ADDENDUM

NO. 1

PROJECT NAME: Tomball ISD Intermediate School Replacement

ADDENDUM DATE: Tuesday, July 28, 2026

1 ROOF FRAMING PLAN - AREA B
S6.07 1/8" = 1'-0"

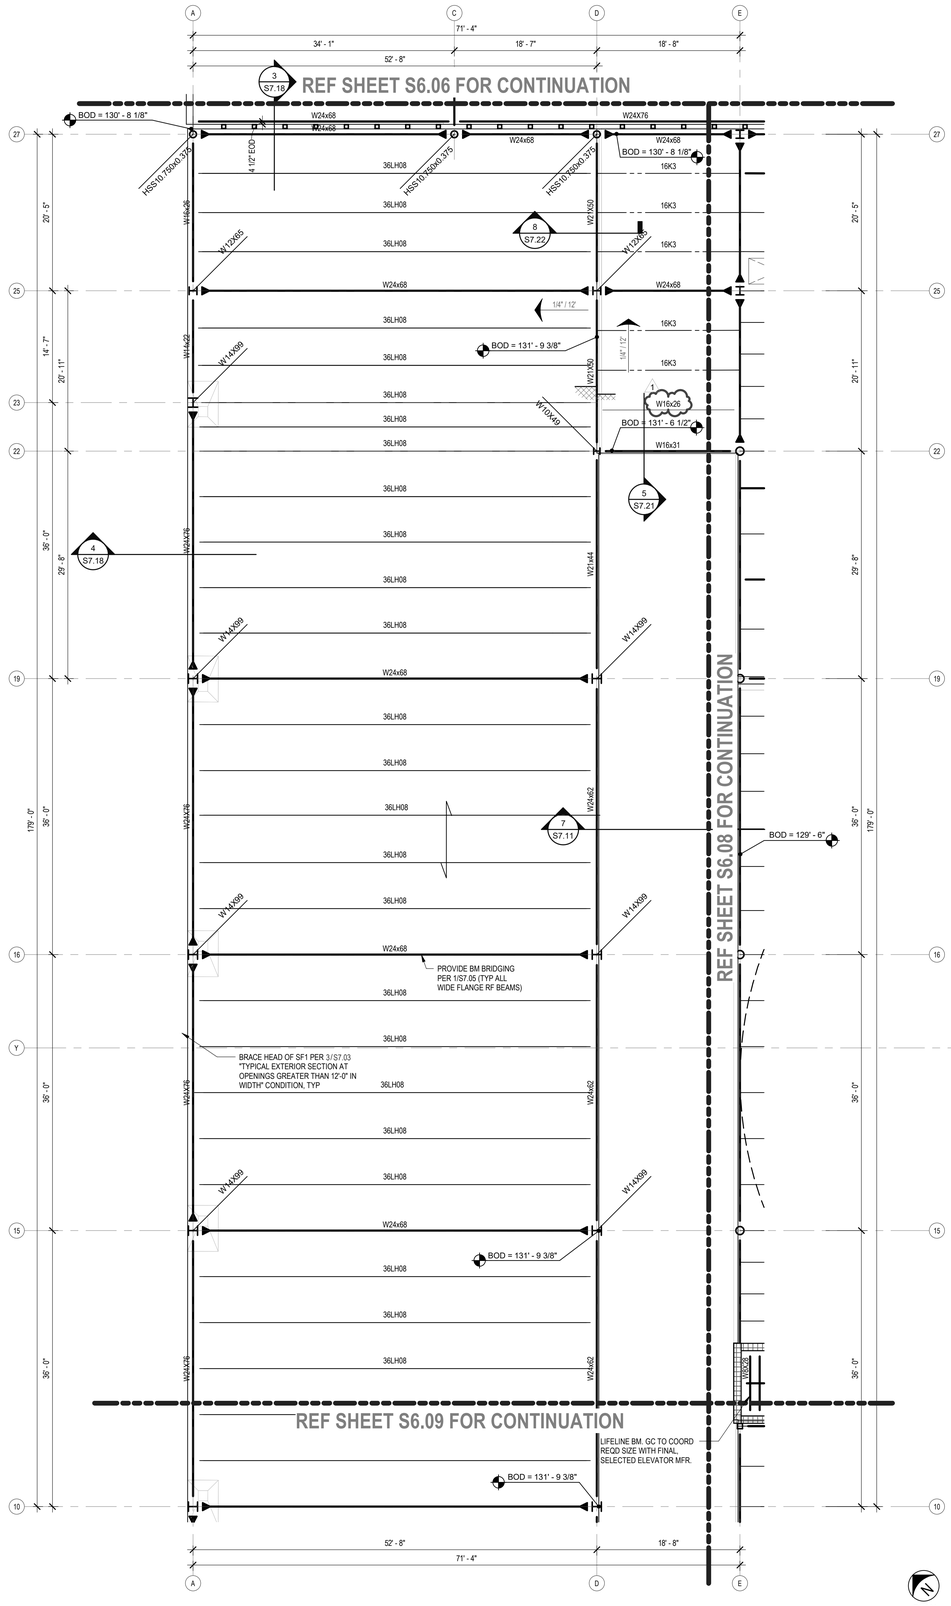
AD No 1, Struc. Item 5: To the Drawings, Sheet S6.07,"ROOF FRAMING PLAN - AREA B"
Changed roof purlin size.

1 ROOF FRAMING PLAN - AREA C
S6.08 1/8" = 1'-0"

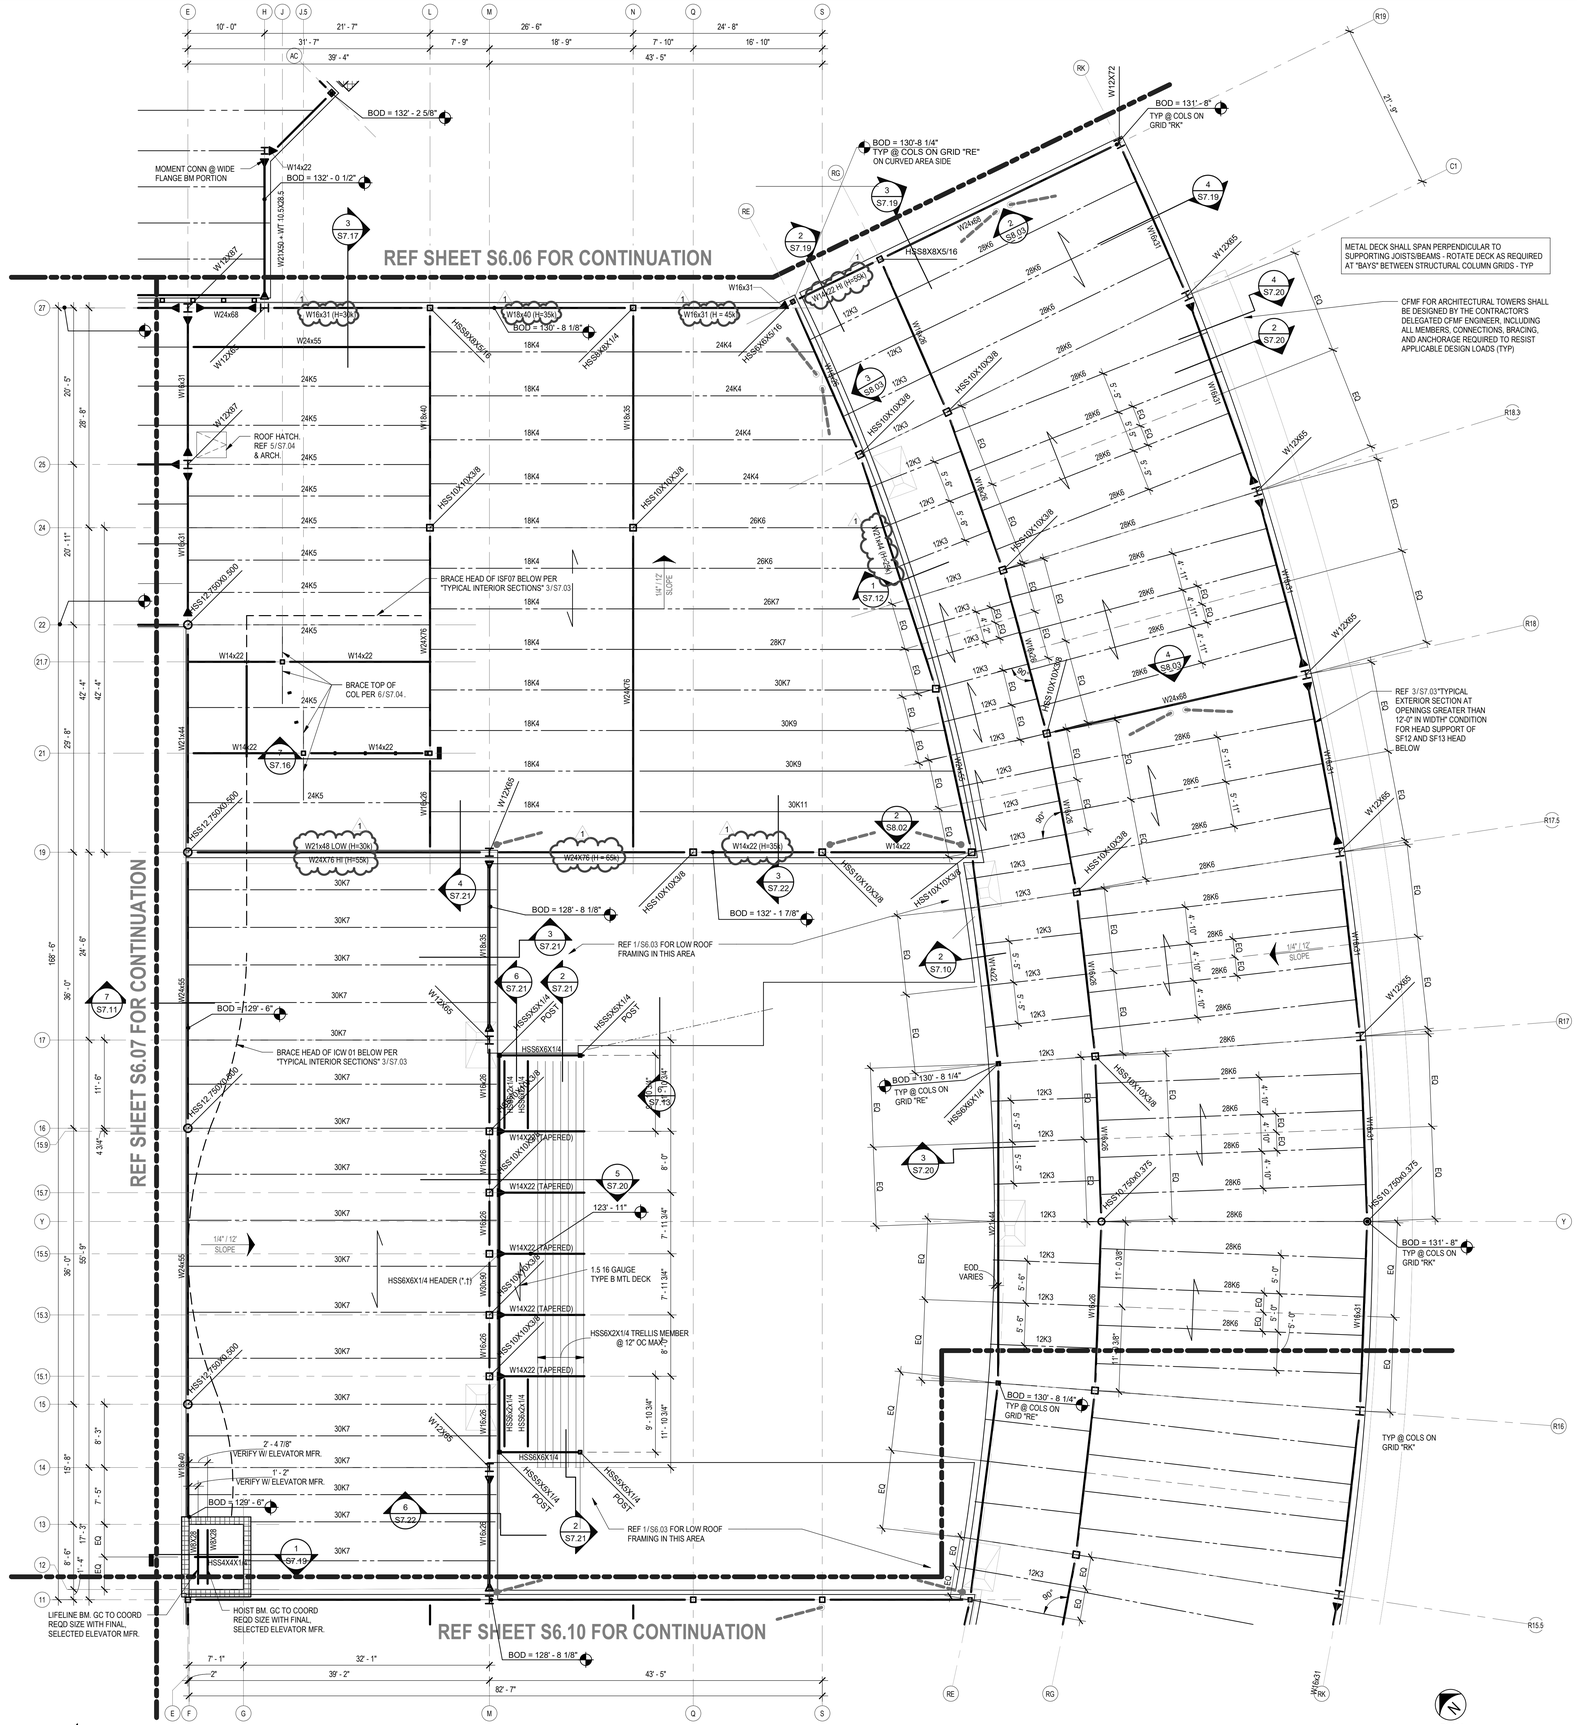
AD No 1, Struc. Item 6: To the Drawings, Sheet S6.08,"ROOF FRAMING PLAN - AREA C"
Added beam axial load notation.

1 ROOF FRAMING PLAN - AREA D
S6.09 1/8" = 1'-0"

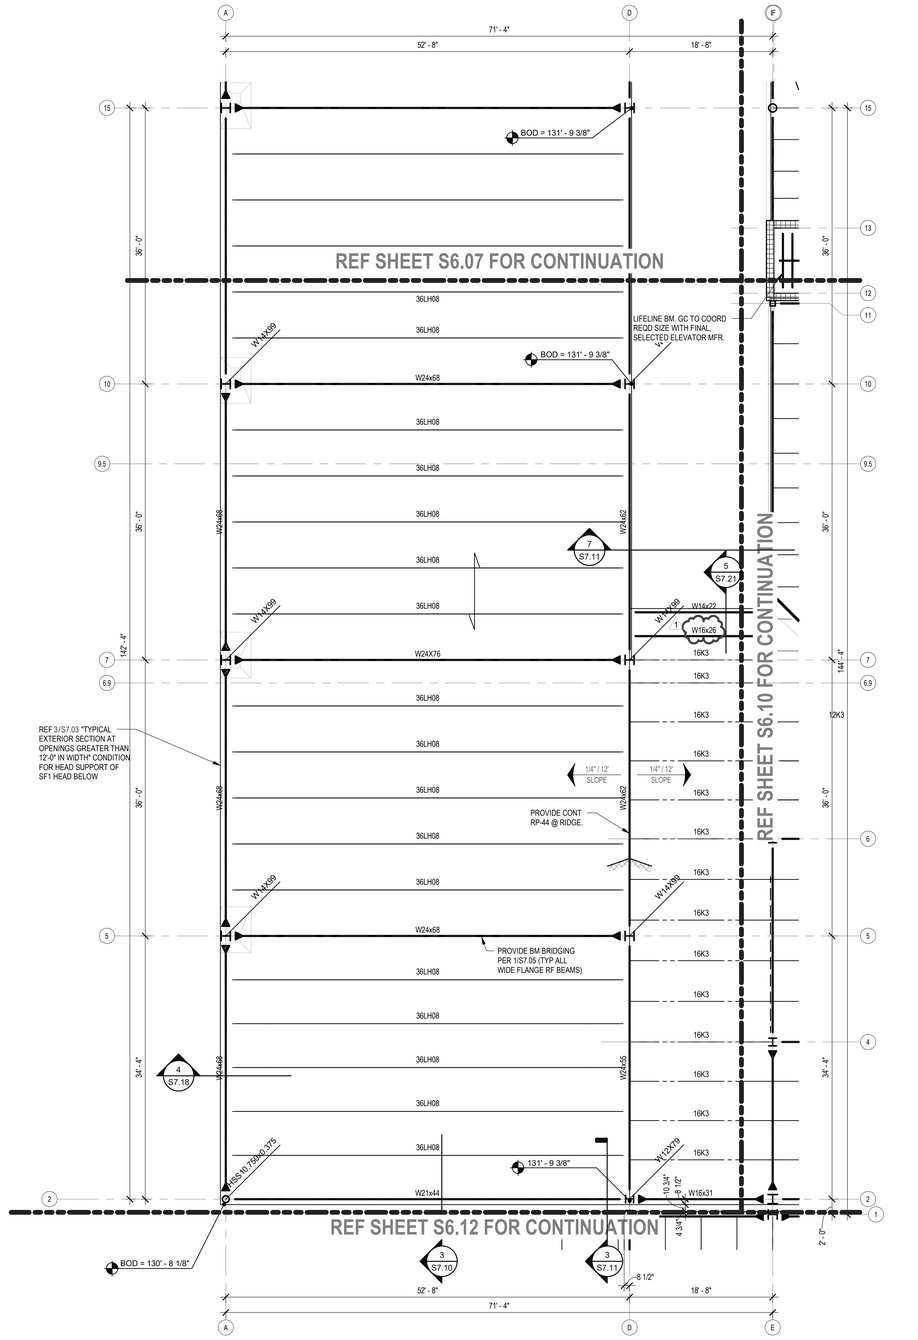
AD No 1, Struc. Item 7: To the Drawings, Sheet S6.09,"ROOF FRAMING PLAN - AREA D"
Changed roof purlin size.

1 ROOF FRAMING PLAN - AREA E

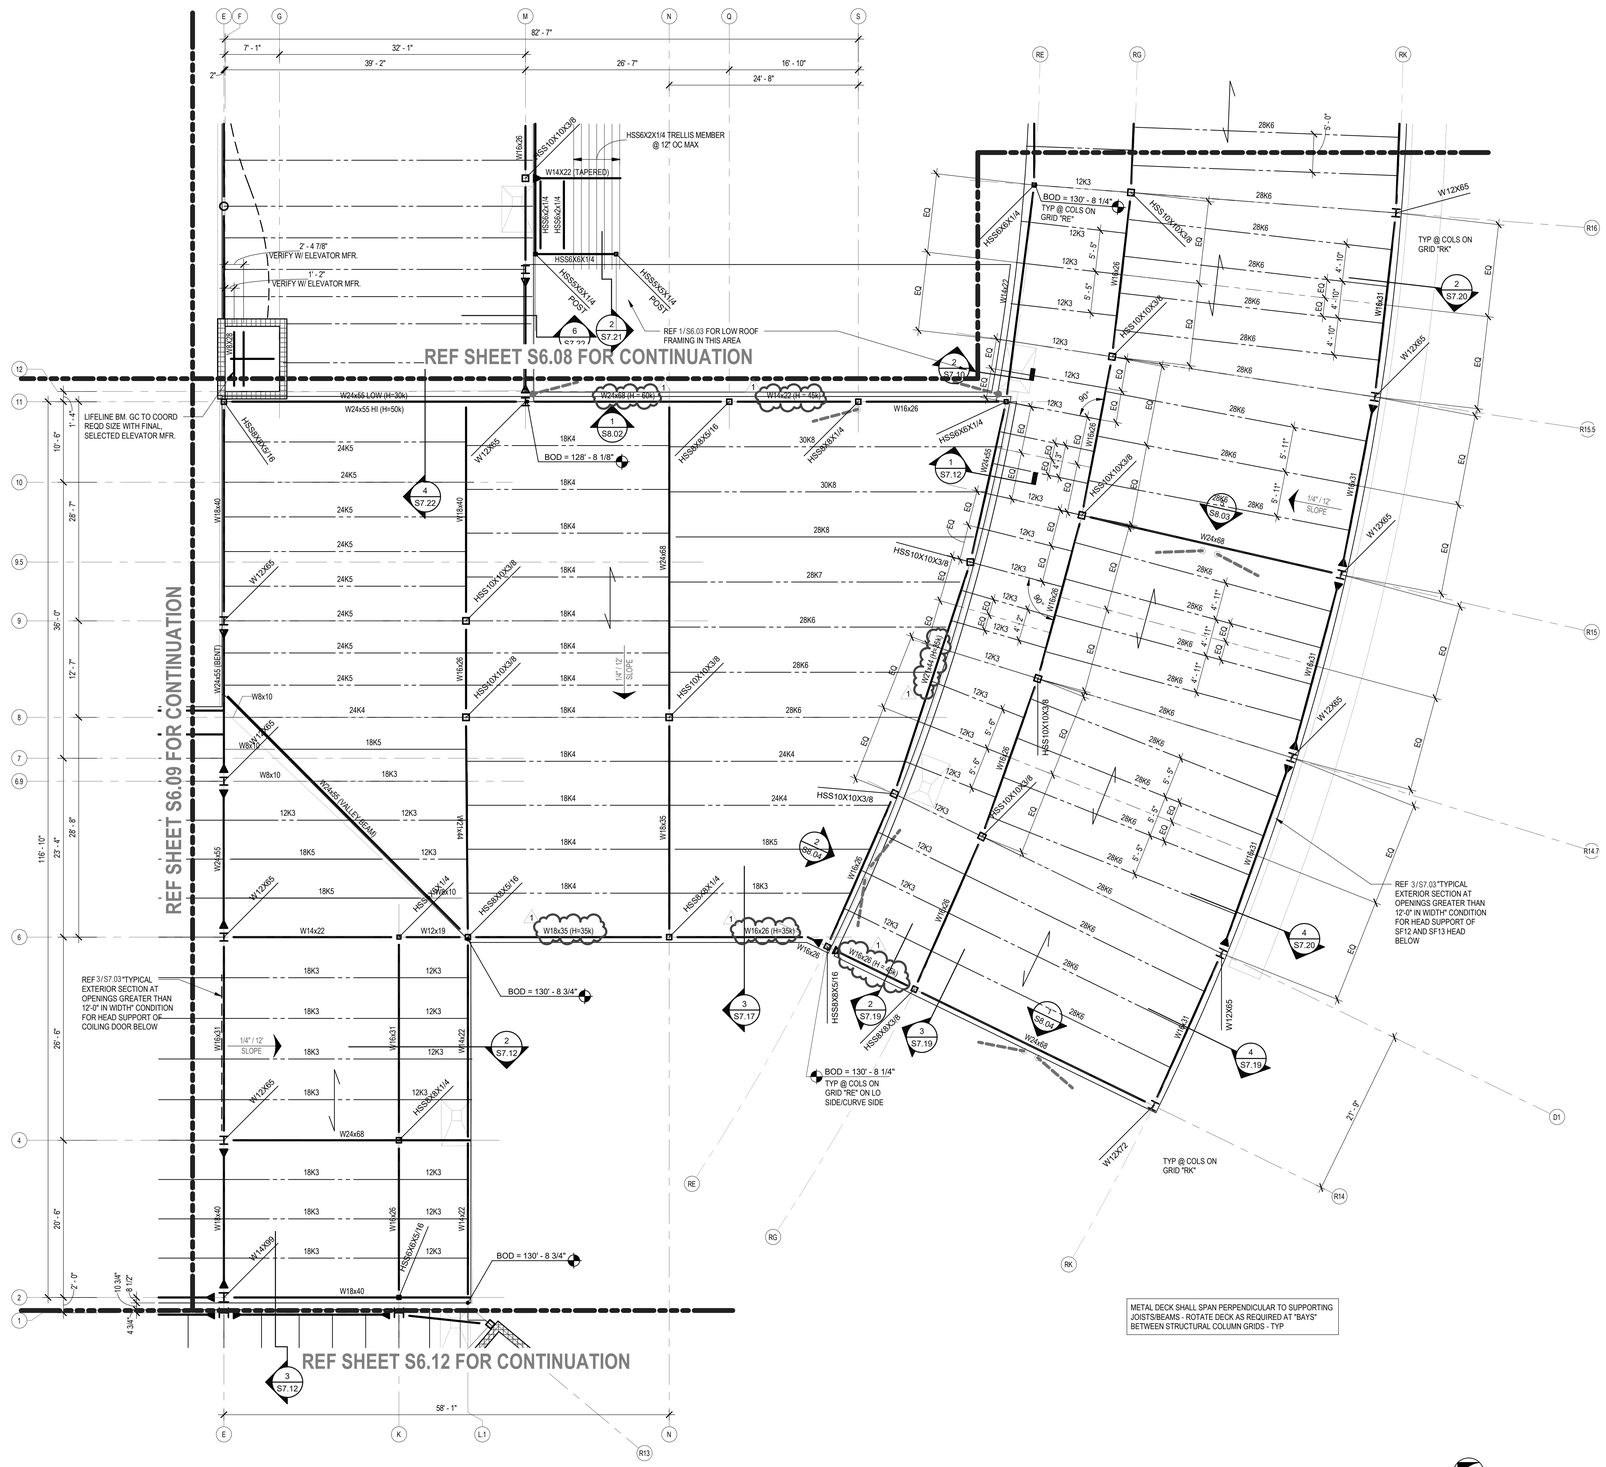
AD No 1, Struc. Item 8: To the Drawings, Sheet S6.10,"ROOF FRAMING PLAN - AREA E"
Added beam axial load notation.

1 ENLARGED FRAMING PLAN - LEARNING STAIR MID-LANDING

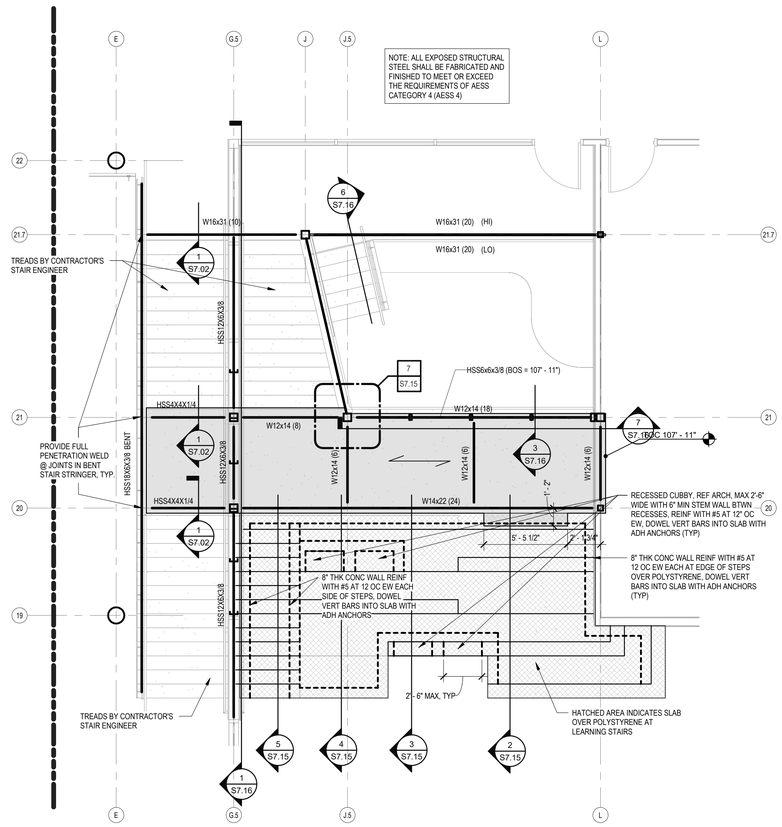
AD No 1, Struc. Item 9: To the Drawings, Sheet S6.13,"ENLARGED FLOOR FRAMING PLANS"
Modified learning stair/nest area.

1 ENLARGED PLAN - ROOF SCREEN
S6.14 1/4" = 1'-0"

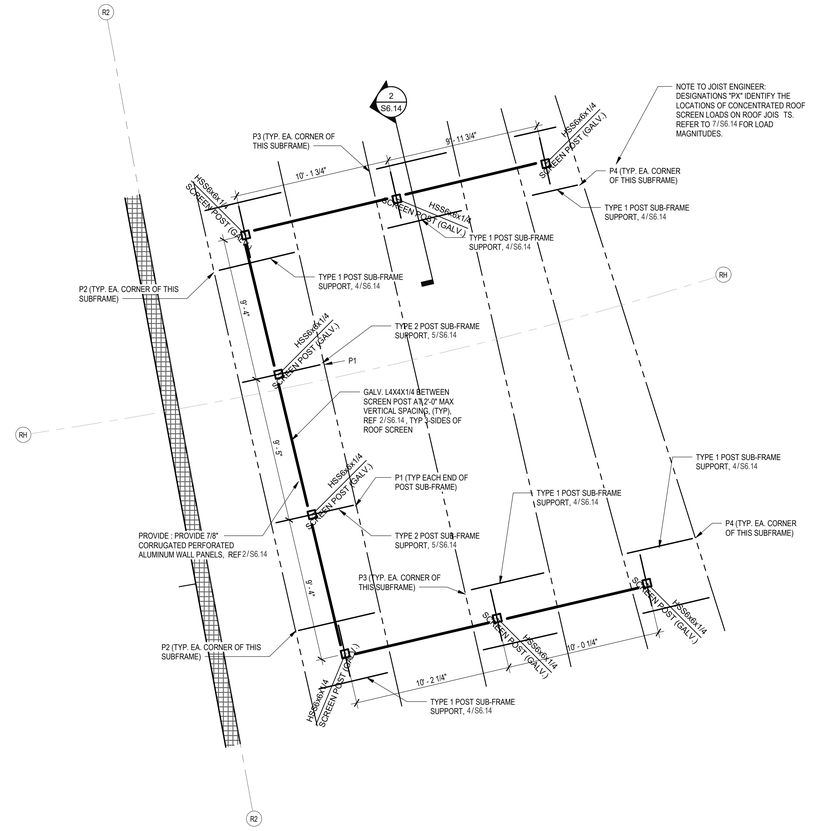
AD No 1, Struc. Item 10: To the Drawings, Sheet S6.14,"ROOF SCREEN PLANS AND DETAILS"
Added new sheet.

1 SECTION
S7.09 1/2" = 1'-0"

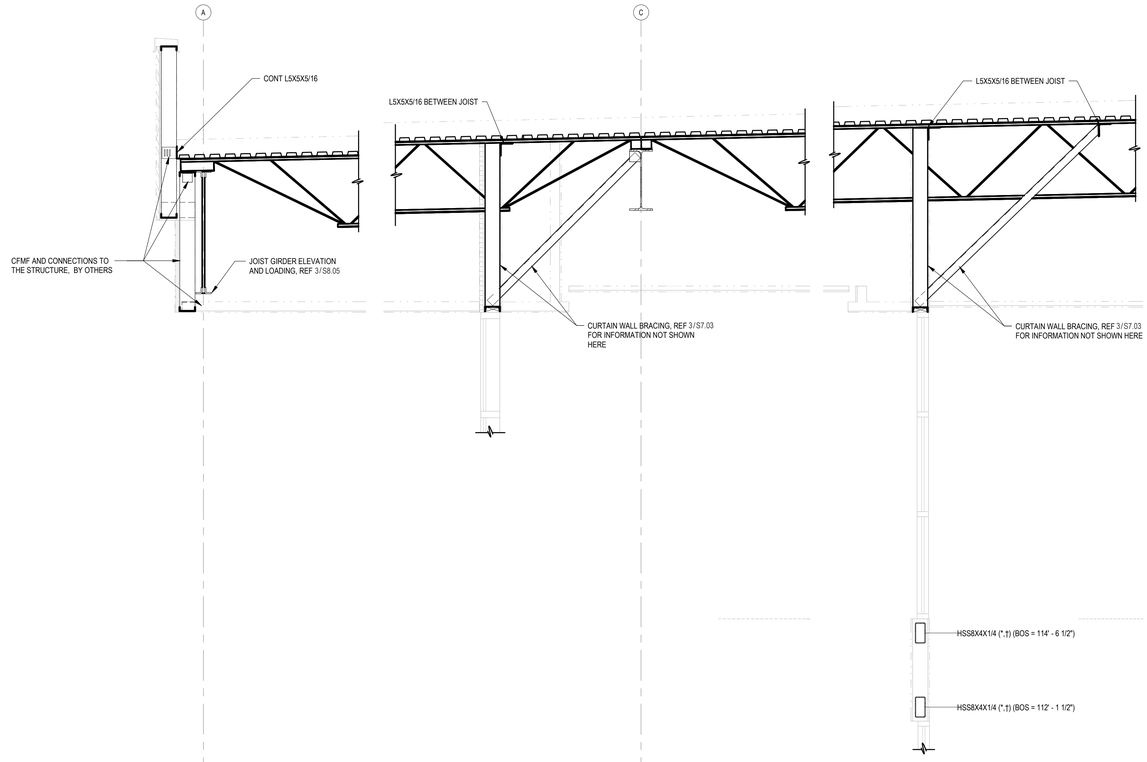
AD No 1, Struc. Item 11: To the Drawings, Sheet S7.09,"FRAMING DETAILS"
Revised detail.

1 SECTION
S7.16 1/2" = 1'-0"

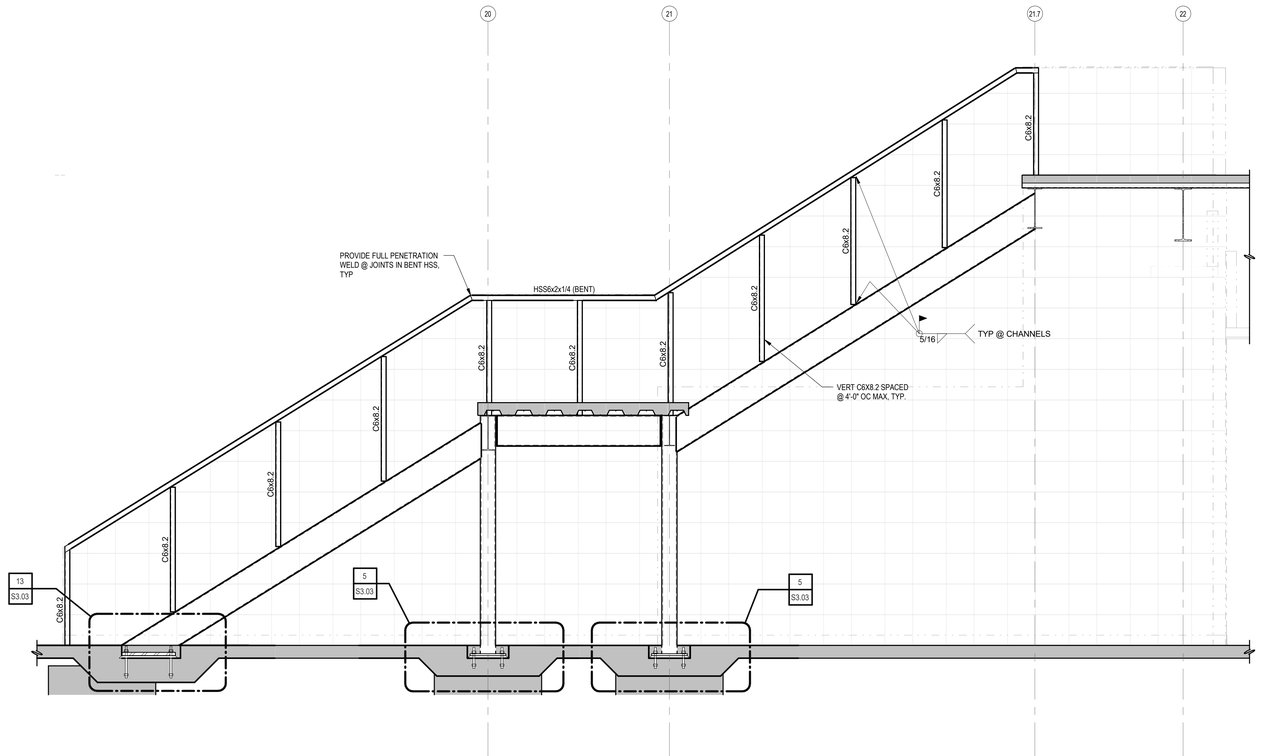
AD No 1, Struc. Item 13: To the Drawings, Sheet S7.16,"FRAMING SECTIONS"
Added, deleted, and revised details.
